ENGINE - FUEL AND CONTROL - PROVIDE NEW PRESSURE CONTROL MANIFOLDS WITH IMPROVED  
CLIPPING - CATEGORY CODE 6 - MOD.ENG-73-0004

V2500-ENG-73-0004

Location of Pressure Control Manifolds  
Fig.1

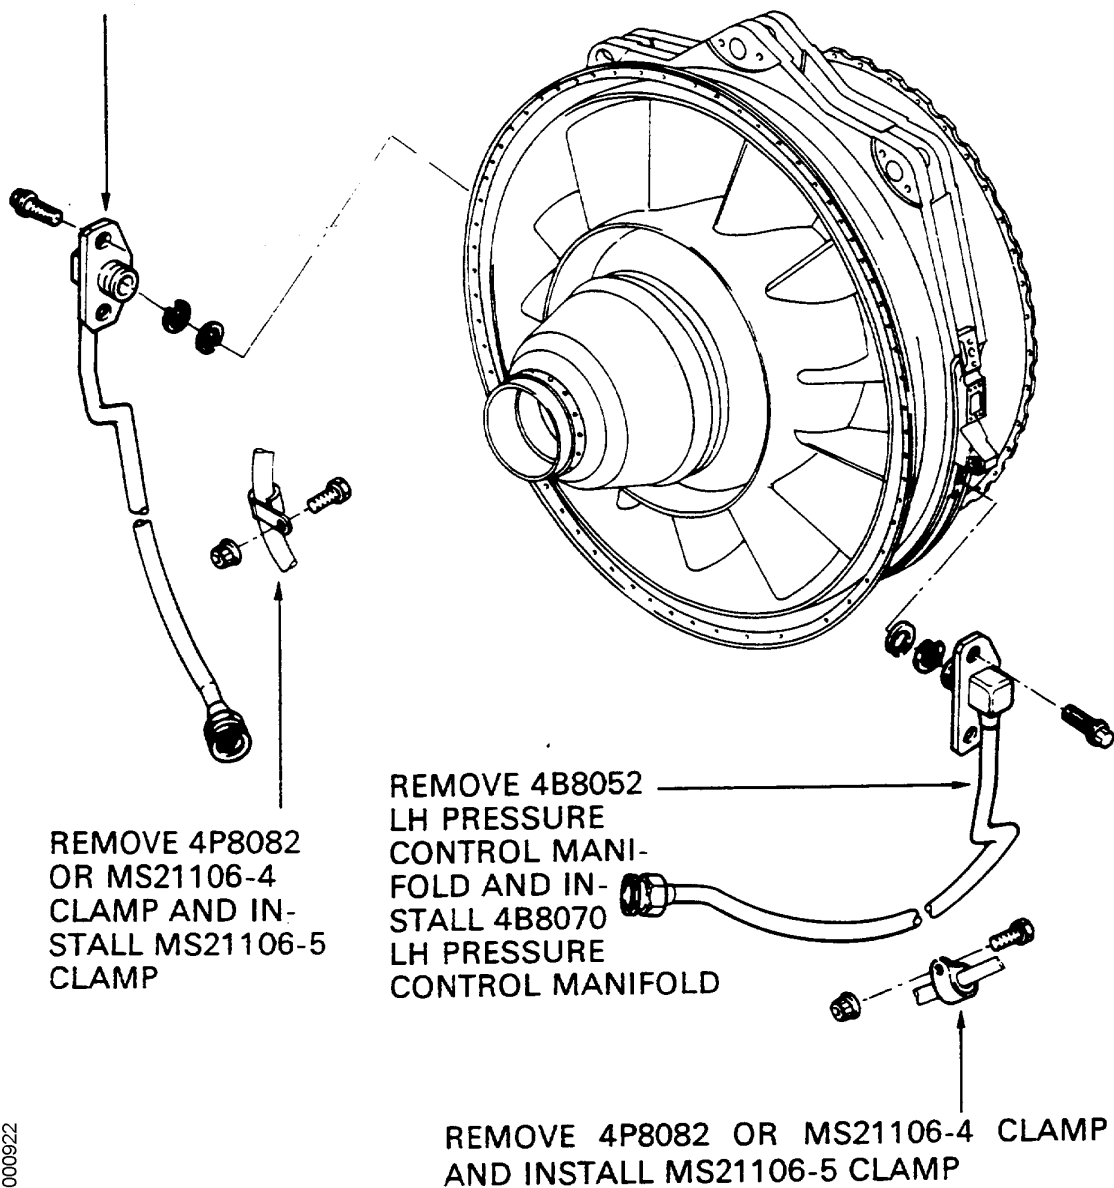
Chafing may occur on both pressure control manifolds at clip position.

When using clamps with stainless steel wire mesh cushions, chafing was found. Brazed wear sleeves added to the tubes at clamping points eliminates the condition.

New pressure control manifold with wear sleeves brazed at the clamping position and new clamps are provided. See Figure 1.

REMOVE 4B8051 RH PRESSURE CONTROL  
MANIFOLD AND INSTALL 4B8069 RH  
PRESSURE CONTROL MANIFOLD

(1) Install the new manifolds by the approved procedures in reference (2)
